6080 Waverly Rd, RPO variance request #1450899

# Deck Site Plan (Old v New) Comparis d 1 5 0 8 9 9

6080 Waverly Road for Robert Hoskinson

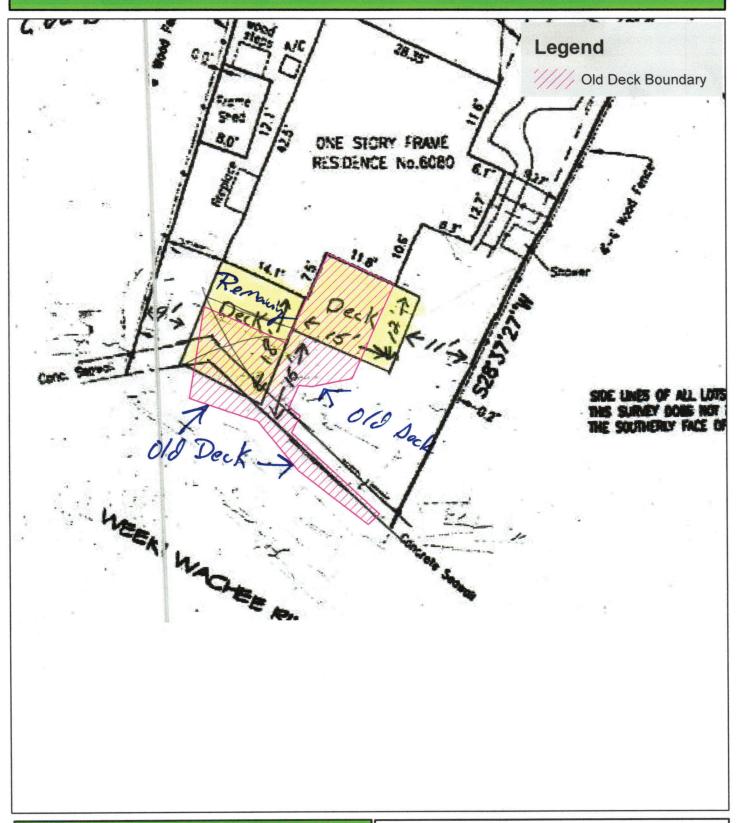
The site plan with existing deck on the western side of the home does not comply with the riverine protection ordinance. There is not a record of a permit for the existing decking or proof supplied yet that it existed prior to 1990. The unpermitted deck extends over the riverine buffer. The portion over the buffer will need to be removed and the site plan modified to show compliance. Unpermitted portions of the structure will also be required to comply with County Code. Contact Jane Brown, Contractor Licensing in the Building Department, regarding the violations and permitting requirements."

Decking discussed in "Request for variance & hardship statement" letter do not have building permits in BLDSYS, and "old deck" and "Remaining Deck" shown on "Exhibit A" do not have permits. The letter lists portions of existing decking permitted under different years, however, this information correlates to the extra features "Parcel Details" on the Property Appraiser's website for this key # (92526) and are not proof of building permits. If the applicant cannot provide physical permits for the decks sited, then the statement needs to be revised. A portion of the adjacent decking, east of the "Remaining Deck" on "Exhibit A" has been removed to meet the 15-foot vegetated riverine buffer requirement. Without a true hardship or good cause the request should be denied.

- 1) Permitting listed in the "Request for variance and hardship statement" need to be submitted as part of the application or the statement revised to reflect accurate information (to request a hardship the activity must have received all agency permits);
- 2) Provide an explanation of good cause (code violations are a result of the applicant's actions);
- 3) Variance form states request is to reduce rear yard setback to 0'. If the applicant is requesting permission to keep an unpermitted deck over the riverine buffer and rivers edge, then the request should include encroachment of the deck structure on the application form and provide total square footage of the encroachment.
